**SUNDRY NOTICES AND REPORTS ON WELLS**  
*Do not use this form for proposals to drill or to re-enter an abandoned well. Use Form 3160-3 (APD) for such proposals.*

8. Well Name and No.  
PUCKETT "A" 4

9. API Well No.  
30-015-05379

Current Wellbore

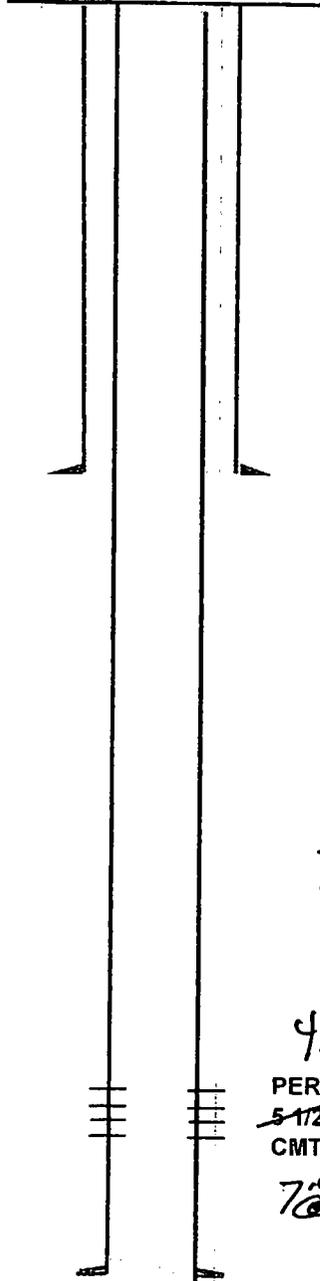
*Records indicate 4 1/2" CG from, 7" pulled from 3108.  
4 1/2" circ. 2 stage.*

Proposed Wellbore

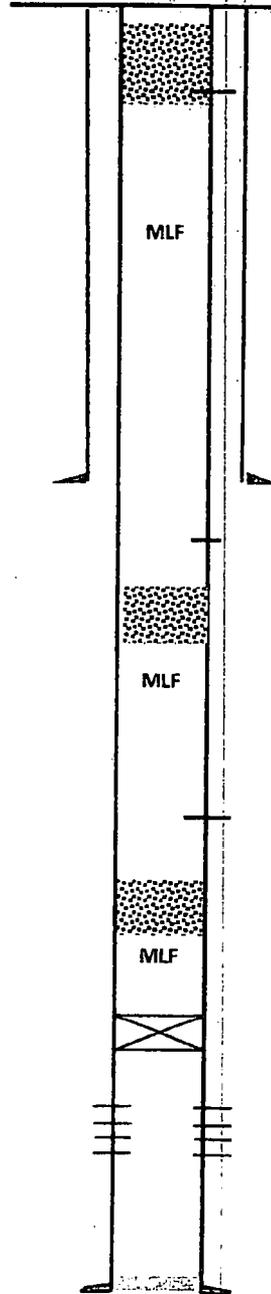
- 1) MIRU, NIPPLE UP BOP.
- 2) RIH & SET CIBP @ 3288' W/25 SX
- 3) TEST 5 1/2" CSG DISPLACE HOLE WITH 9.5 PPG MLF
- 4) SPOT 25 SX "C" CMT ON TOP OF CIBP *Adequate cmt to tag @ 3041 (OVT)*
- 5) PERFORATE 5 1/2" CSG @ 1830' AND SQUEEZE WITH 35 SX "C" CMT *Spot 25 sx from 1824 - 1706 Top.*
- 6) PERFORATE 5 1/2" CSG @ 690' AND SQUEEZE WITH 75 SX "C" CMT *Spot 25 sx from 780 - 580. Tag.*
- 7) PERFORATE 5 1/2" CSG @ 60' AND CIRCULATE CLASS "C" CMT UPTO SURFACE *Perf both 4 1/2" and 8 5/8" Circ to surf.*
- 8) CUT OFF WELL HEAD, VERIFY CMT AT SURFACE IN 5 1/2" X 8 5/8" ANNULAS PERFORM REMEDIAL CMT WORK IF NECESSARY
- 9) INSTALL BELOW GROUND DRY HOLE MARKER, CUT OFF ANCHORS
- 10) RIP AND REMOVE CALICHE, CONTOUR TO SURROUNDING TOPOGRAPHY AND RESEED
